PLANS FOR  
 ESPARANZA HILLS SUB. AND  
 ESPARANZA HILLS TWO SUB.  
 WATER LINE AND ACCESS RD.

RECEIVED  
 JUL 30 2007  
 ENGINEERING DEPT.  
 COPY  
 RELOCATE  
 WATER LINE  
 0000 ESPARANZA HILLS  
 18000081

**GRADING PLAN AND SWPP PLAN**  
**ESPERANZA HILLS TWO SUBDIVISION**  
 LOCATED IN THE EAST 1/2 NE 1/4 AND THE NE 1/4 SE 1/4 OF SECTION 14, TOWNSHIP 35 NORTH, RANGE 6 WEST, BOISE MERIDIAN, CITY OF LEWISTON, NEZ PERCE COUNTY, IDAHO  
 JULY, 2007

**AREA DRAIN TYPE I**

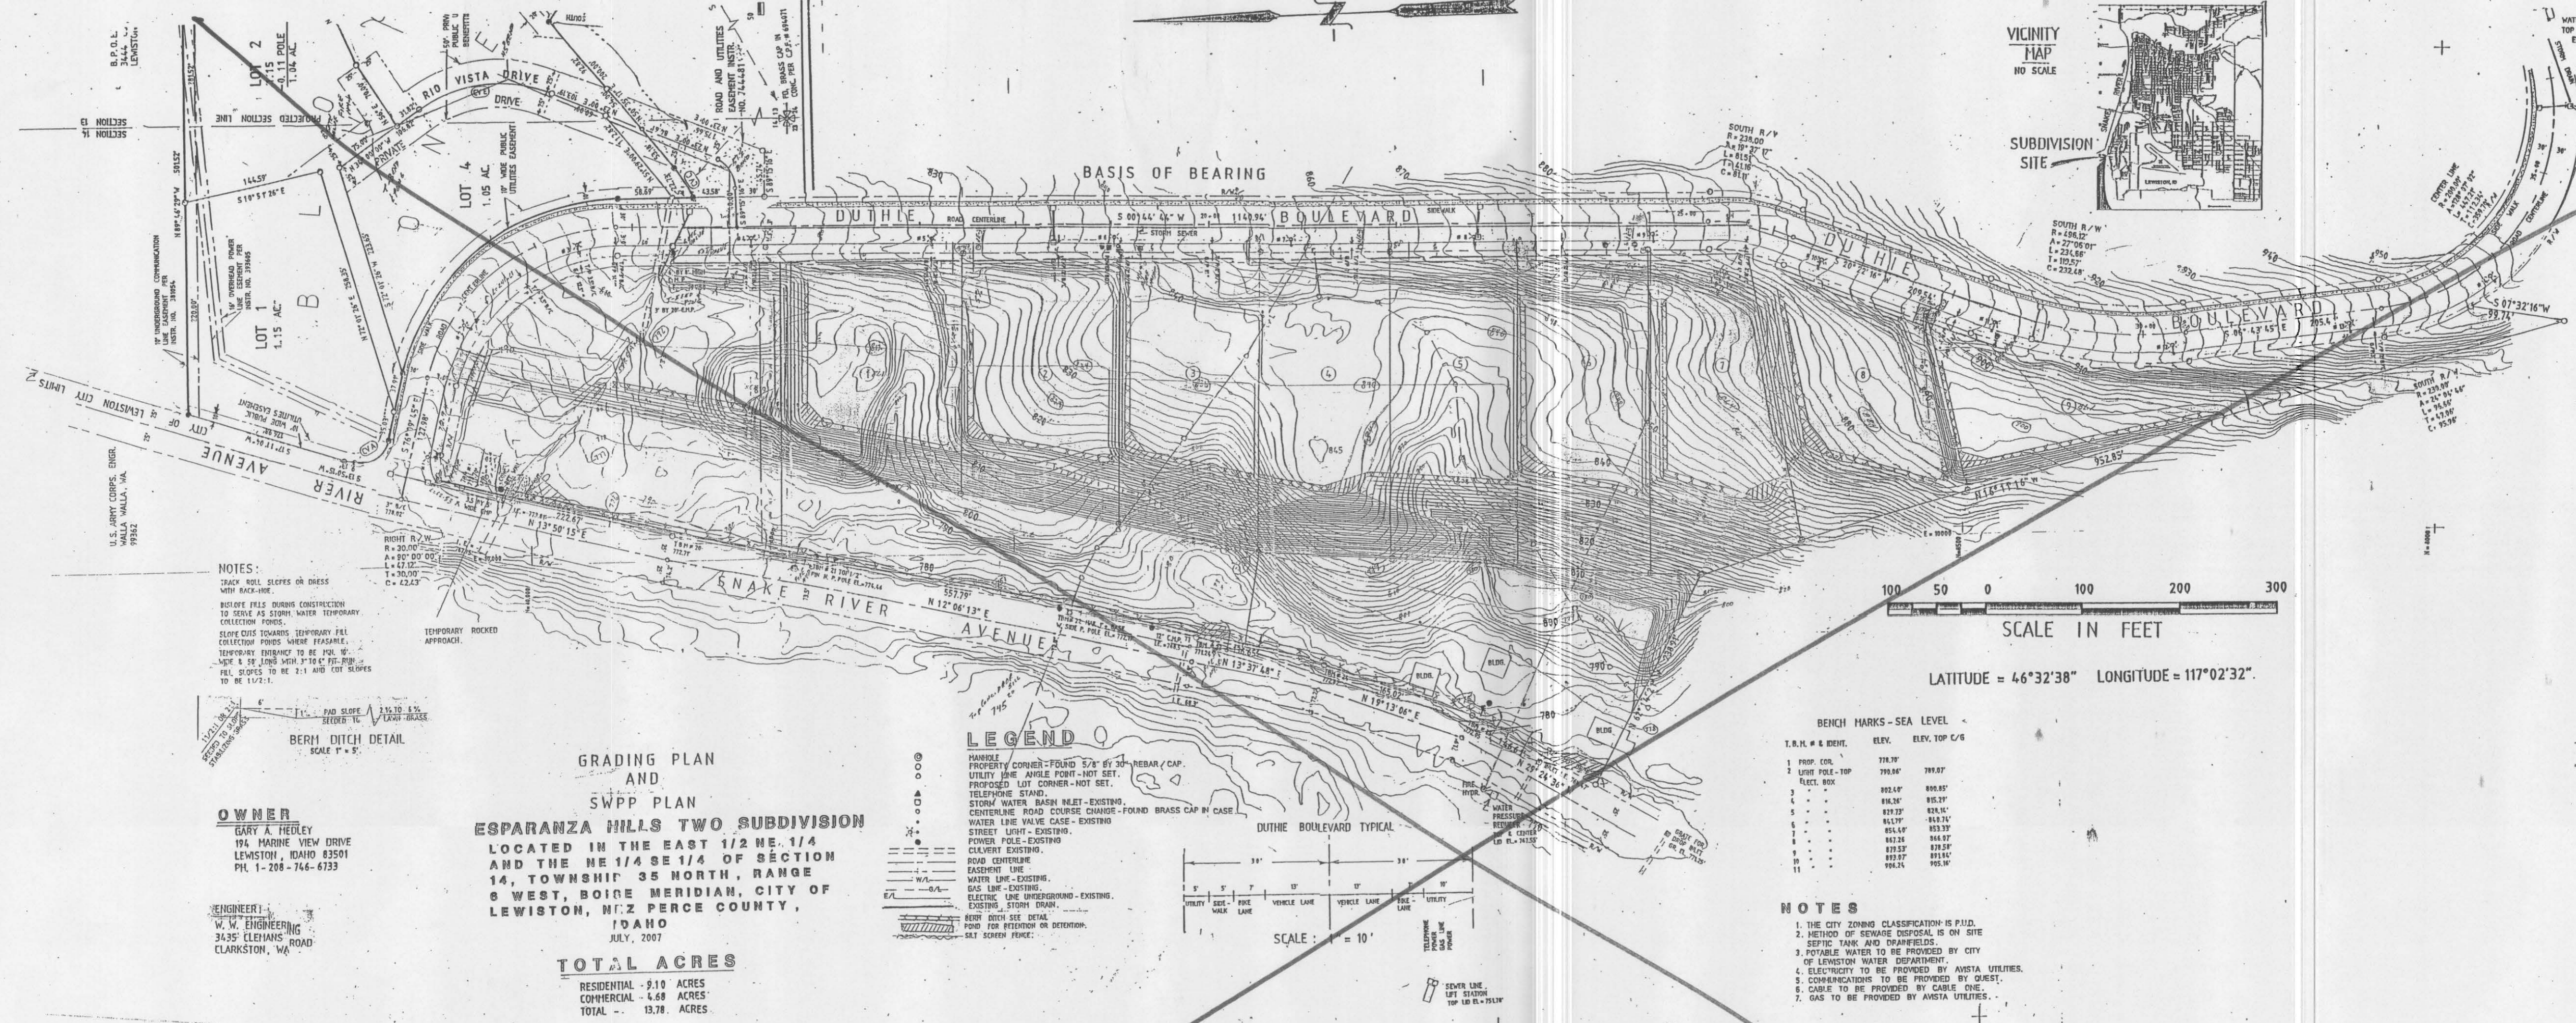
These details do not apply to water line improvements.

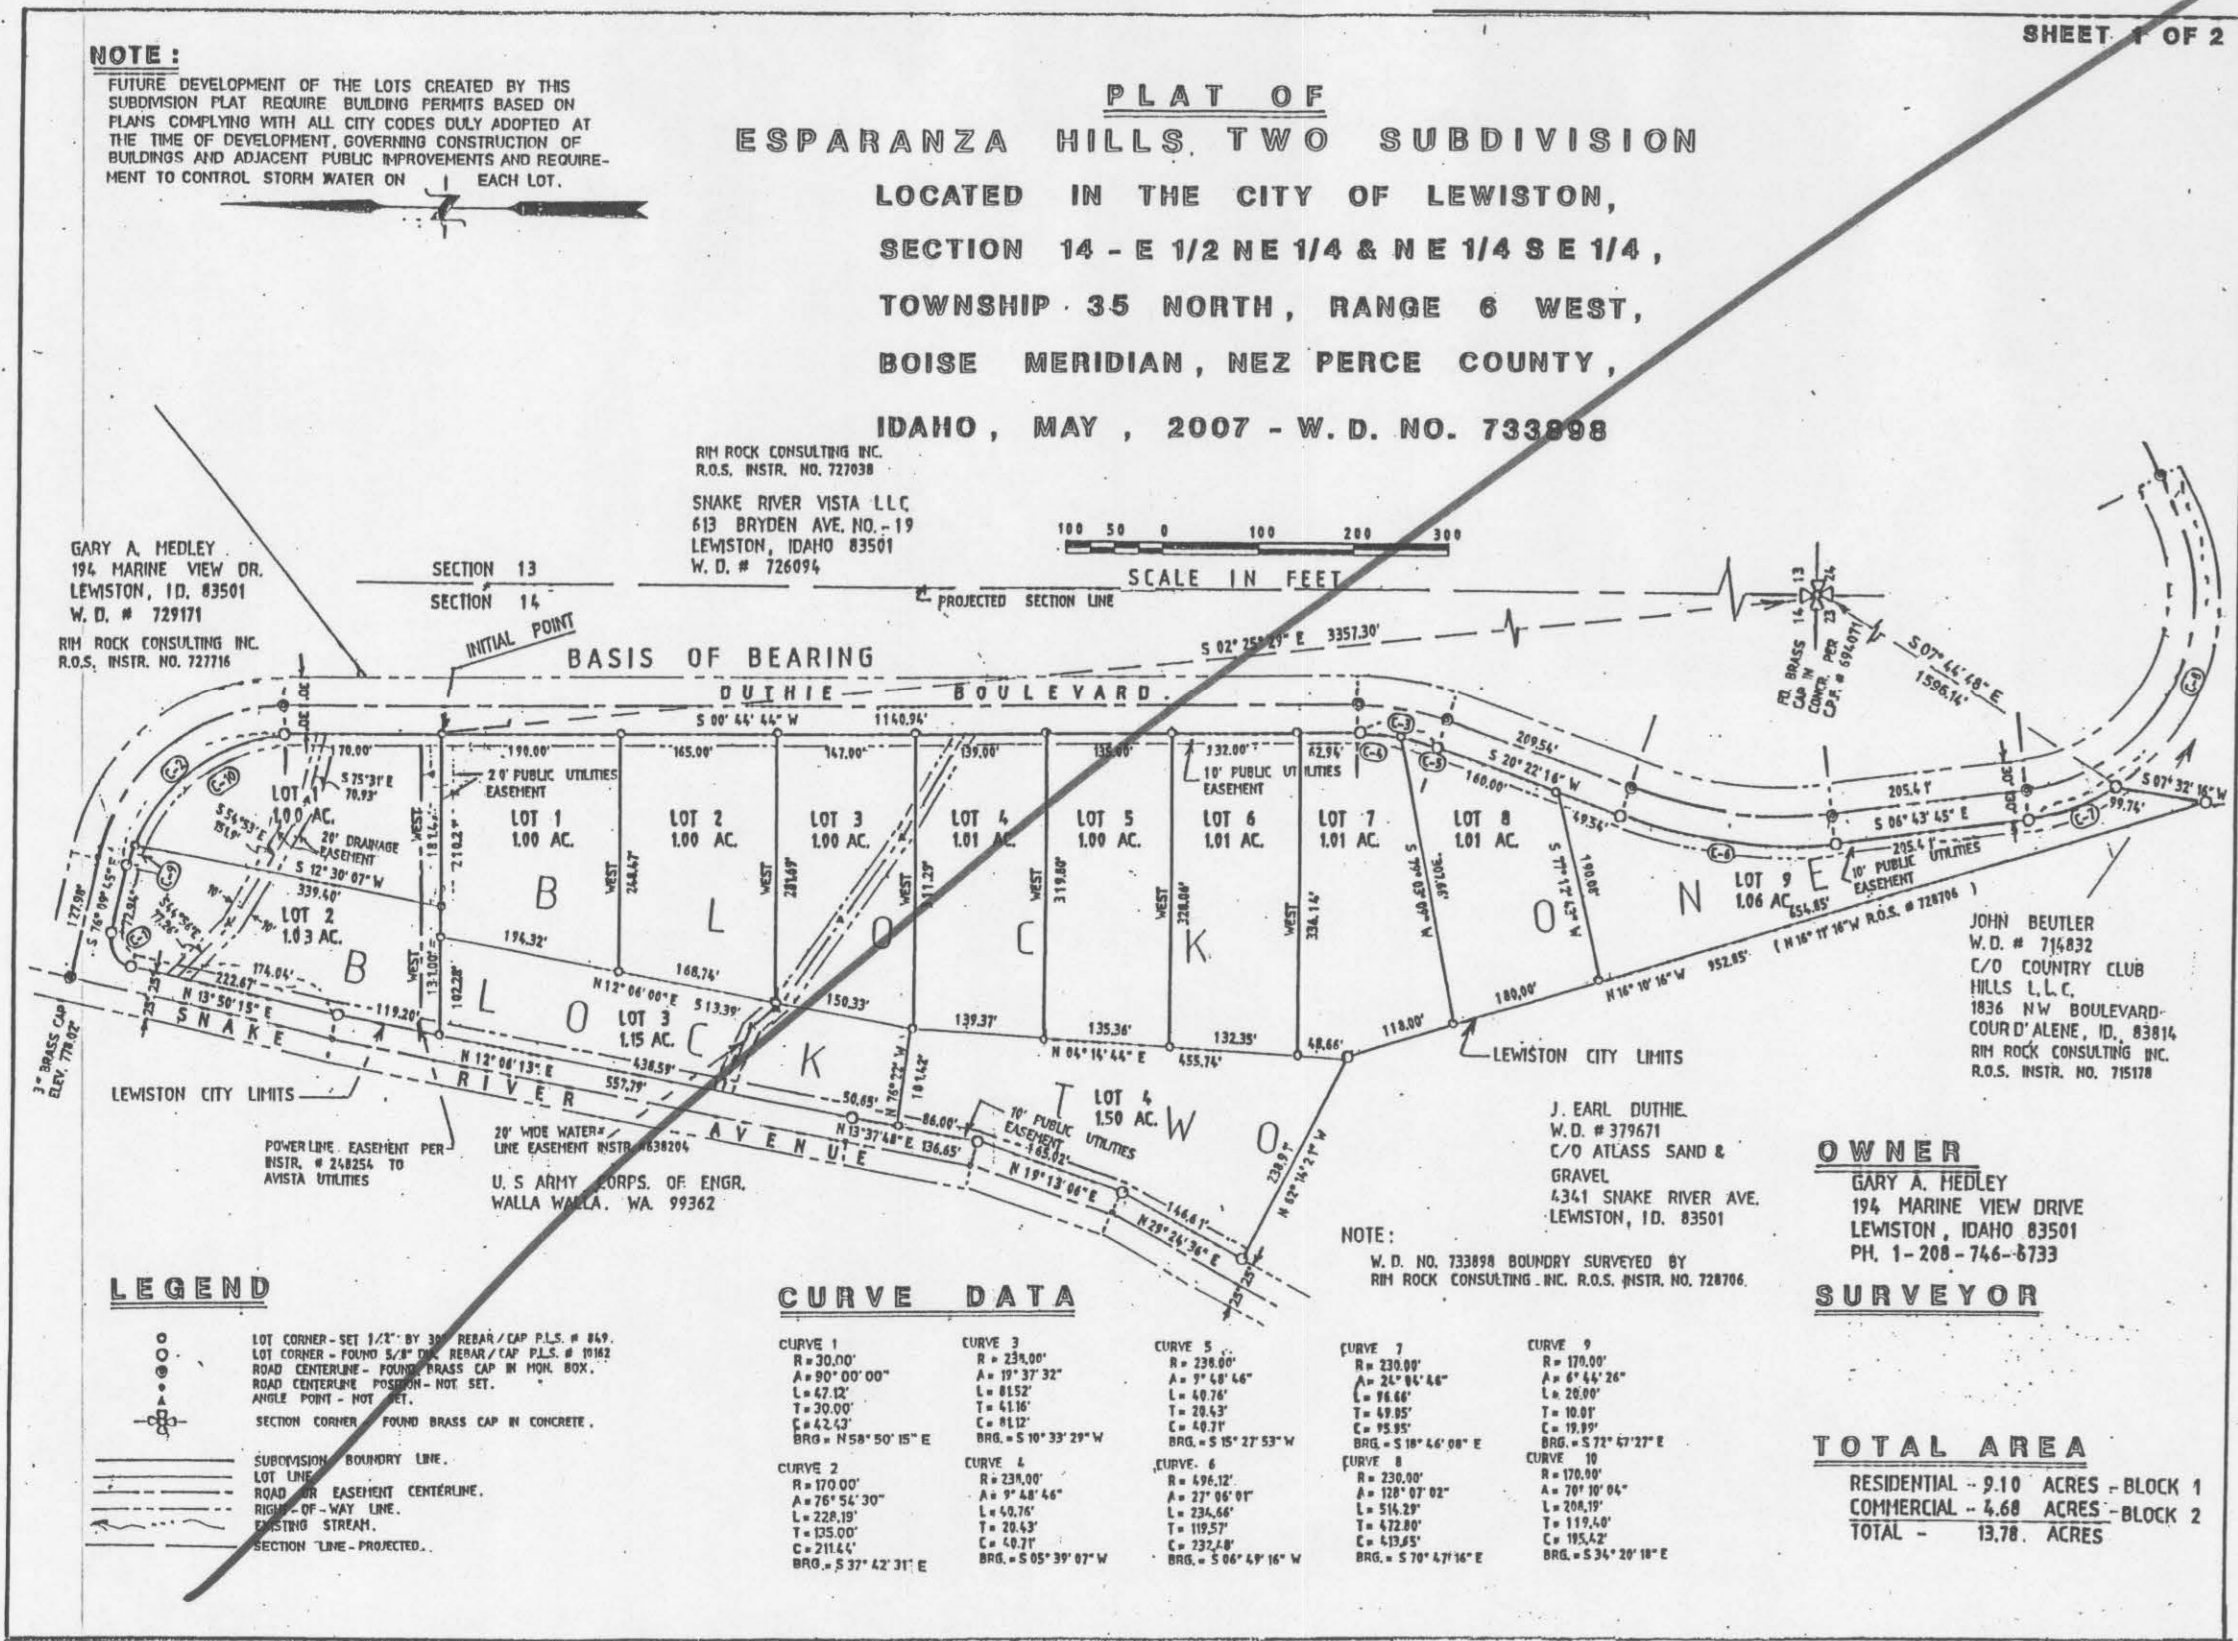
*Plat not approved.*  
 David Husted

*The grading and SWPP plan do not apply to waterline and are not approved.*  
 [Signature]
